**5 Aeolus Street, Ryde - LDA2021/0445**

**Demolition, construction of 48 place child-care centre**

**City of Ryde  
Local Planning Panel Report**

<b>DA Number</b>	LDA2021/0445
<b>Site Address &amp; Ward</b>	5 Aeolus Street, Ryde Lot 10 DP 7159 Central Ward
<b>Zoning</b>	R2 Low Density Residential
<b>Proposal</b>	Demolition of structures and child care centre
<b>Property Owners</b>	Mr N Navasardian and Mrs S Navasardian
<b>Applicant</b>	Mr Nigel White, Planning Direction P/L
<b>Report Author</b>	Holly Charalambous, Senior Coordinator Development Assessment
<b>Lodgement Date</b>	23 December 2021
<b>No. of Submissions</b>	Fifteen (15) submissions objecting to the development and 1 petition consisting of 12 signatures during the first notification period.
<b>Cost of Works</b>	\$2,470,050.00
<b>Reason for Referral to Local Planning Panel</b>	<b>Contentious Development</b> – More than 10 unique submissions objecting to the proposal have been received as a result of public notification of the application - Schedule 1, Part 2 of Local Planning Panels Direction and <b>Departure from development standards</b> – contravention of the floor space ratio development standard by more than 10%

**Figure 10:** The Level 1 Plan comprising the indoor and outdoor (rear terrace) space for 16 x 0-2 year olds and associated cot rooms, a nappy change room, toilets and laundry. An office and mother's feeding room is also provided.

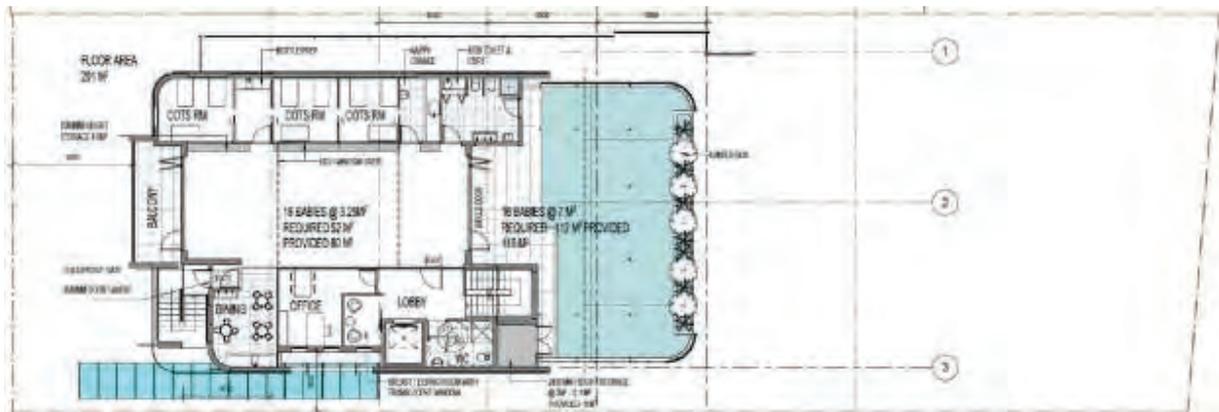
The Level 1 Plan does not specify the fitout of the external play area for 0-2 year olds. The design guidelines for outdoor space (discussed in detail below) is not satisfied. However, given this balcony is capable of being appropriately embellished, as an individual matter, this does not warrant the refusal of the DA.

**Figure 12:** The Landscape Plan showing the plantings and play features of the rear outdoor play area.

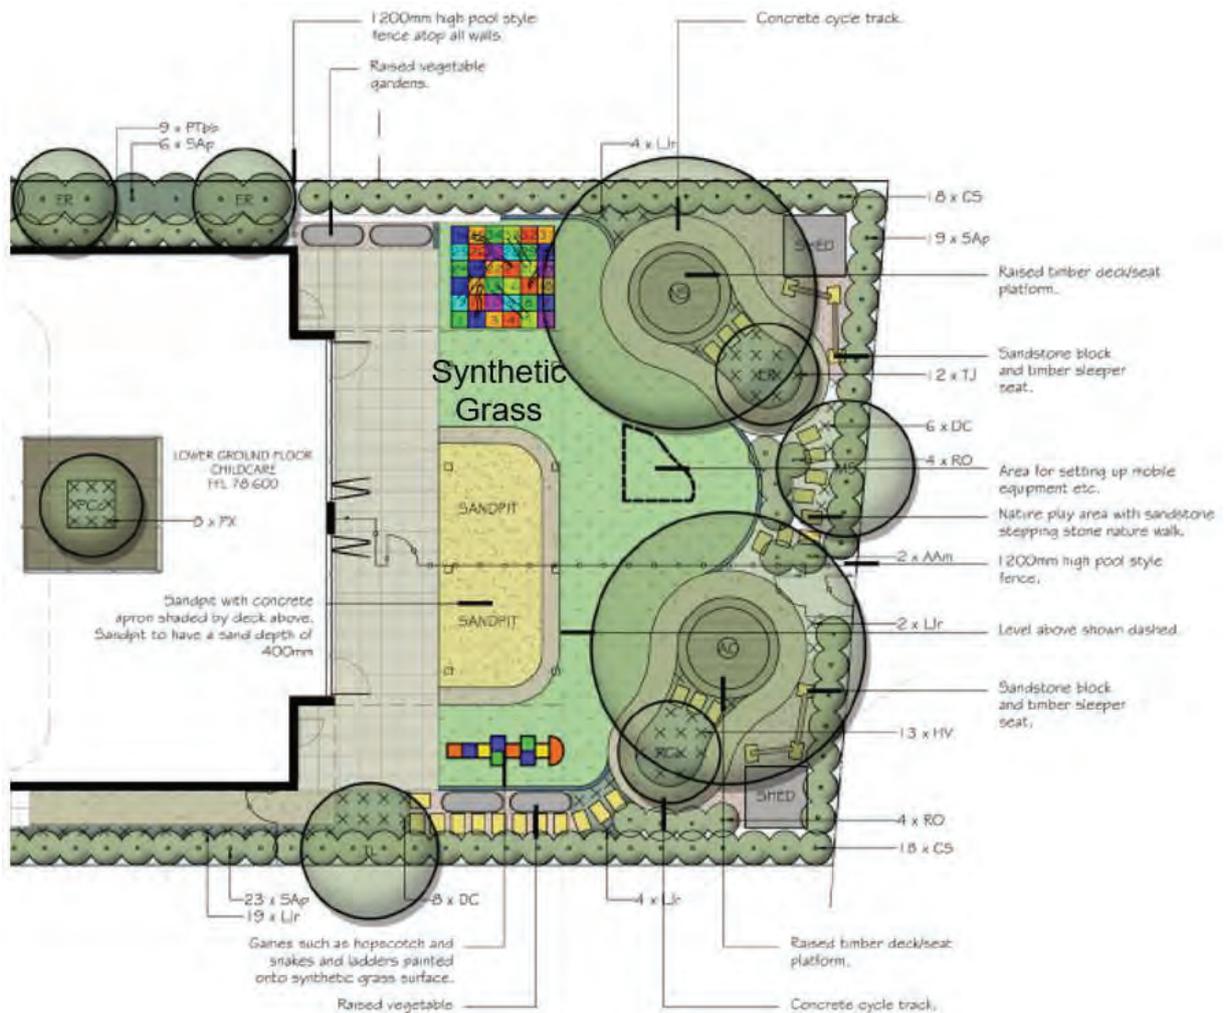
- i 30% natural planting area (excluding turf);
- ii 30% turfed area; and
- iii 40% hard surfaces (sand paving, timber platforms)

- i 22% natural planting area (excluding turf);
- ii 23% turfed area; and
- iii 50% hard surfaces (sand paving, timber platforms)

The applicant has also failed to provide details of the distinct play areas and embellishment of the first floor balcony.

The applicant has failed to submit amended landscape plans to respond to this issue. The lack of soft landscaping is not supported.

**Figure 19:** Extract from the Section A-A Plan showing the extent of excavation in red.

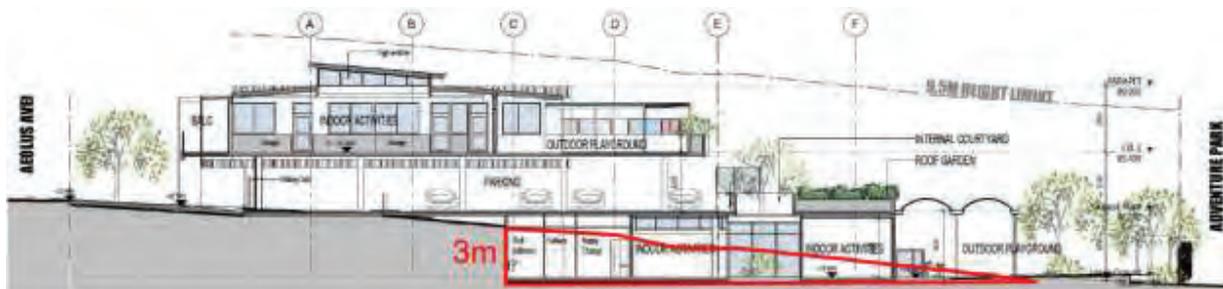
The proposal is for excavation for a depth of up to 3m associated with the Lower Ground Level as shown in **Figure 19** below. It is noted that demolition of the existing structures will be sought in a separate application.

The proposed split level building design results in the excavation at the central part of the site and allows for lift and stair access to each level. The levels at the boundaries of the site are maintained to mitigate potential impacts on the amenity of the adjoining properties. The proposal is considered to satisfactorily avoid, minimise and mitigate the potential impacts of the works and will not adversely affect the use of the land as a child care facility. The proposal is considered to satisfy this clause given the potential impacts of the earthworks.

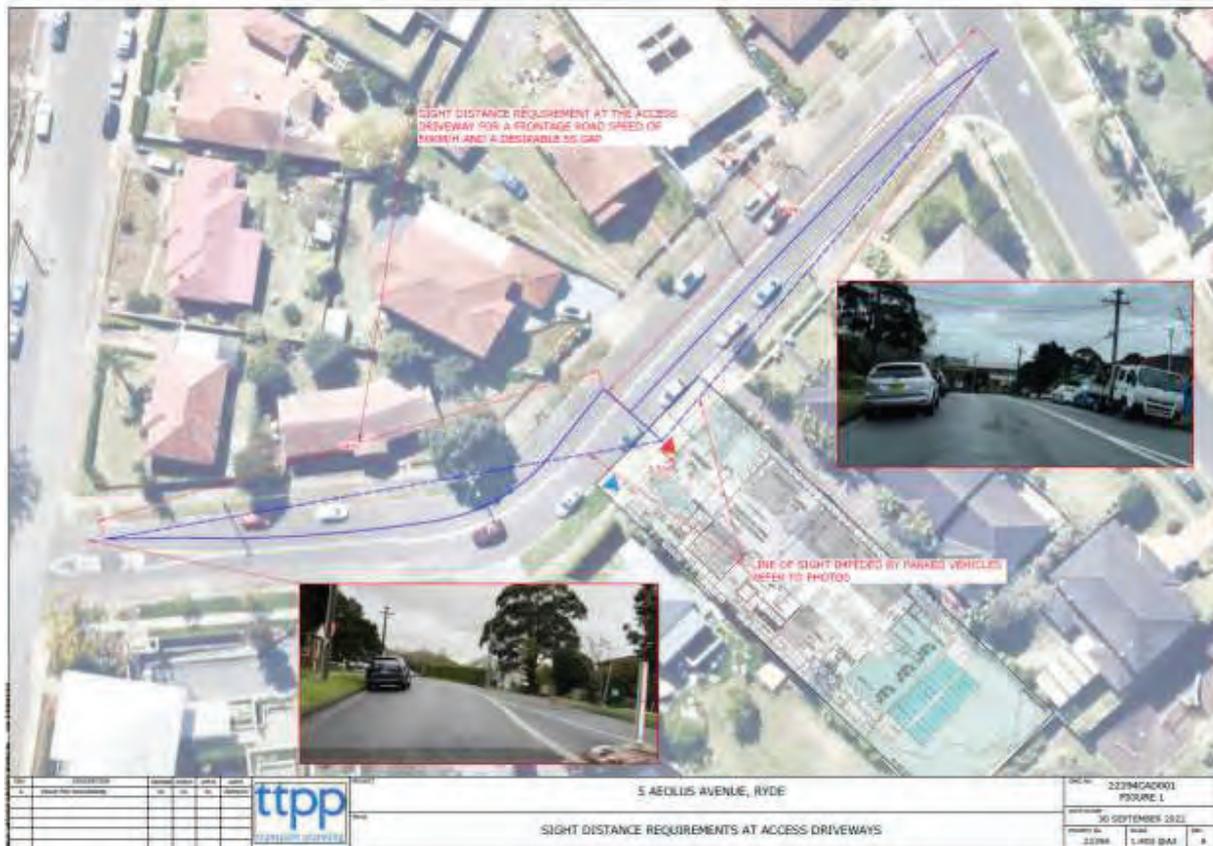
4. Sight distance is impeded by parked vehicles on both sides of Aeolus Avenue as shown in **Figure 22** below. As a result, the egress movement would be unsafe due to the restrained sight distance caused by the parked vehicles on both sides of the driveway.

**Figure 28:** Extract from the 'Drainage through Parks application' dated 2021 showing the location of the Council approved connection within Adventure Park (circled in red).

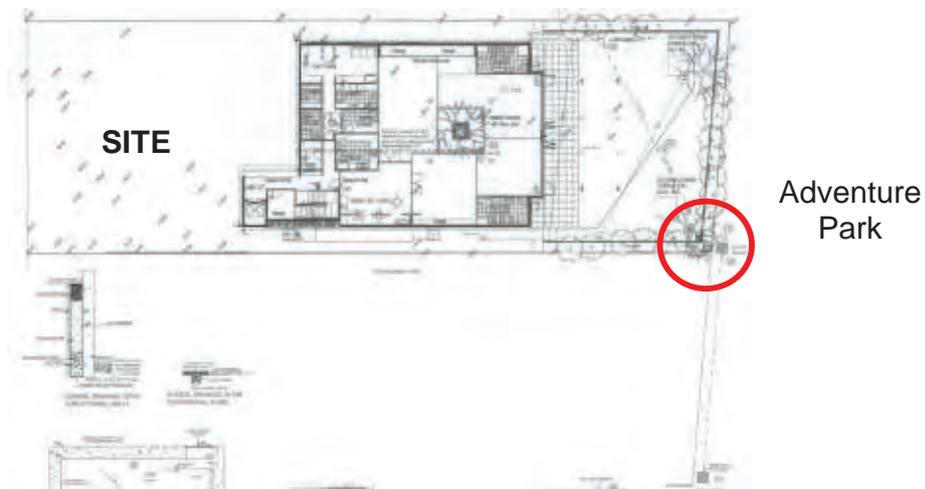
**City Works – Drainage:** Council's Senior Civil Engineer has provided commentary regarding the applicant's proposal to connect their stormwater drainage system to existing public infrastructure located within Adventure Park (owned by Council). This existing pipe runs parallel to the rear boundary and is 1m outside of the applicant's site. Council's Engineer acknowledges that 'Drainage through parks application' dated 08/09/2021 was previously approved for a point of connection as shown in **Figure 28** below.

The above connection point is still permitted by Council's Civil Engineer. However, the subject DA proposes to connect their stormwater at a different location as shown in **Figure 29** below.

To achieve this new location specified by the applicant in **Figure 29** above, the applicant is required to obtain written permission from the owners of No. 7 Aeolus Avenue (being the upstream property) to connect to their existing pit and pipeline which drains through Adventure Park.

Notwithstanding, Council's Civil Engineer has advised that conditions of consent are capable of being imposed should a consent be issued requiring the stormwater connection to reflect the point of discharge shown in **Figure 28** above as reflected in the 'Drainage through Parks application' dated 2021.

Figure 1: 5.2 Long Parking Spaces

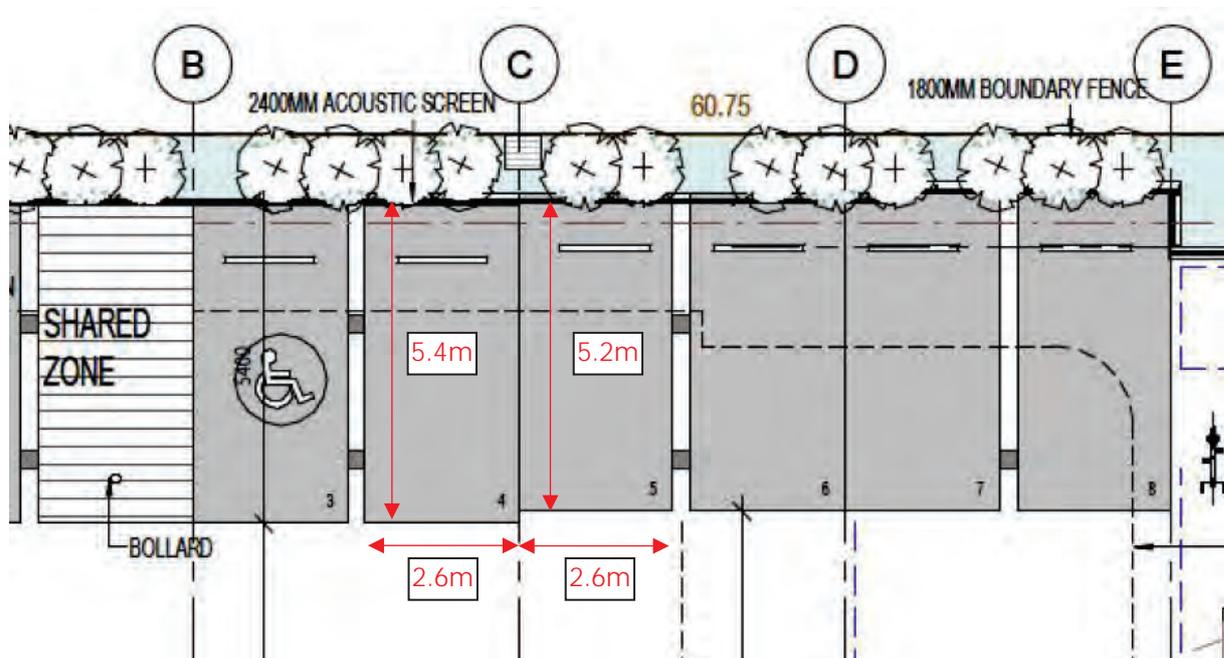
The latest car park design provides 11 parking spaces, although it is not clear which are staff and which are drop off spaces. While most parking spaces are designed to provide compliant dimensions of 5.4m x 2.6m (noting that the staff spaces could be reduced to a 2.4m width), Bays 5 to 8 appear to provide a length of 5.2m which is limited to the rear by a 2.4m high acoustic screen, thus the parking spaces cannot overhang into the landscaped area.

If these are designated spaces for small cars, this would exceed the maximum 10% requirement in accordance with Ryde Development Control Plan 2014 (DCP) Part 9.3 Parking Control. The DCP stipulates that:

Figure 3: Google Typical Traffic Conditions (Tuesday 3:30pm)

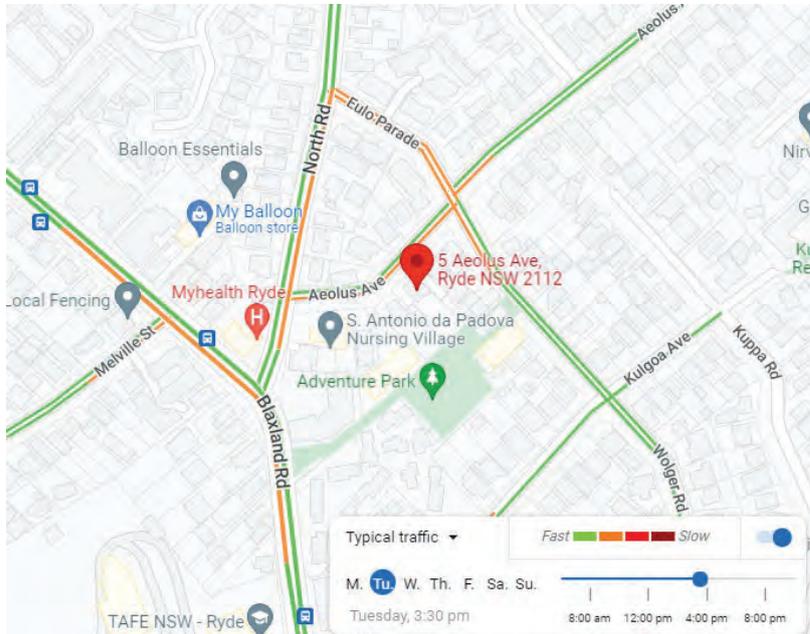
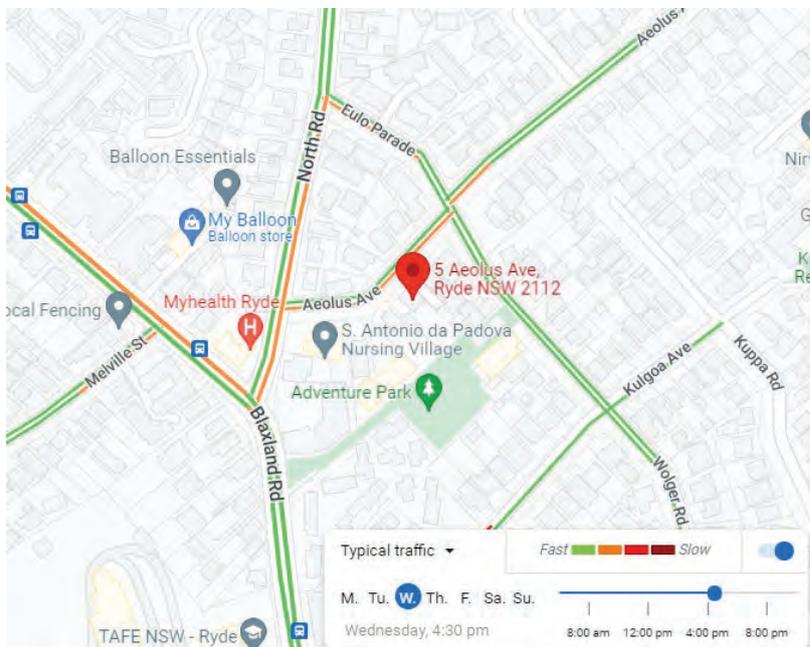
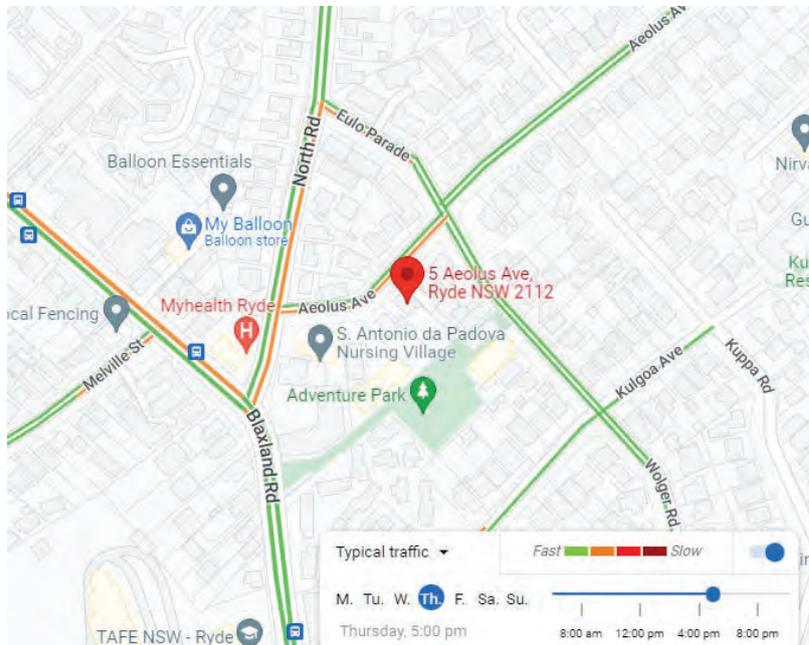
A review of Google Map Traffic Conditions indicates slow vehicle speeds (i.e. rolling traffic queues) on Aeolus Avenue and North Road in the PM peak period. This is possibly due to the restriction of the southbound right turn from Lane Cove Road southbound to Blaxland Road, which would result in the use of Aeolus Avenue as a possible access route towards Blaxland Road. Operating conditions of the North Road- Aeolus Avenue intersection therefore depend on the traffic conditions of the downstream Blaxland Road- North Road intersection.

As shown in Figure 3 to Figure 5, the queue length on Aeolus Avenue westbound is subject to the traffic conditions on North Road being extended from the Blaxland Road intersection. However, this was not recorded in the traffic report's June 2021 data to enable a direct comparison.

Figure 7: Sight Distance Assessment

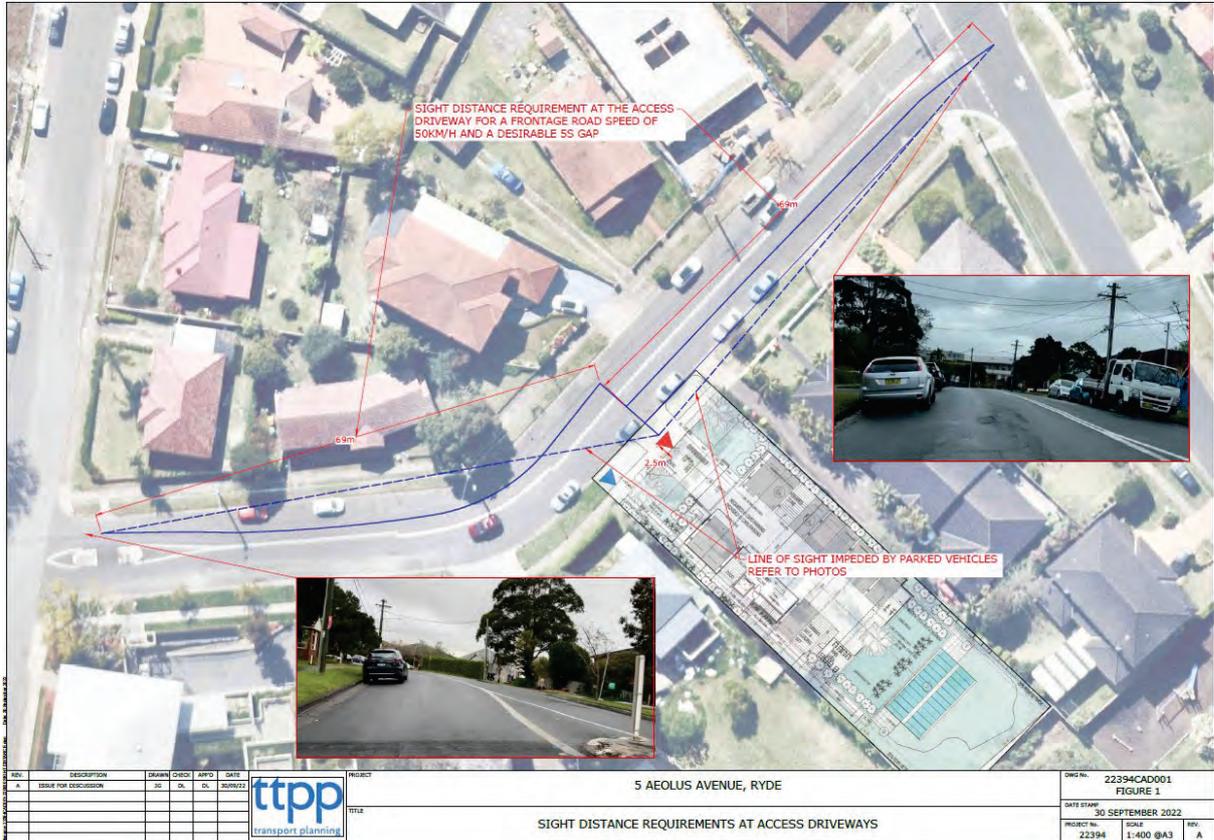
TTPP has undertaken a sight distance assessment as shown in Figure 7 which indicates that the sight distance is impeded by parked vehicles on both sides of Aeolus Avenue. An enlargement of the sight distance assessment is shown in Attachment One.

As a result, and whilst we note that this is an existing condition, a significant increase in the number of egress movements would increase safety concerns due to the constrained sight distance caused by the parked vehicles adjacent on both sides of the road.
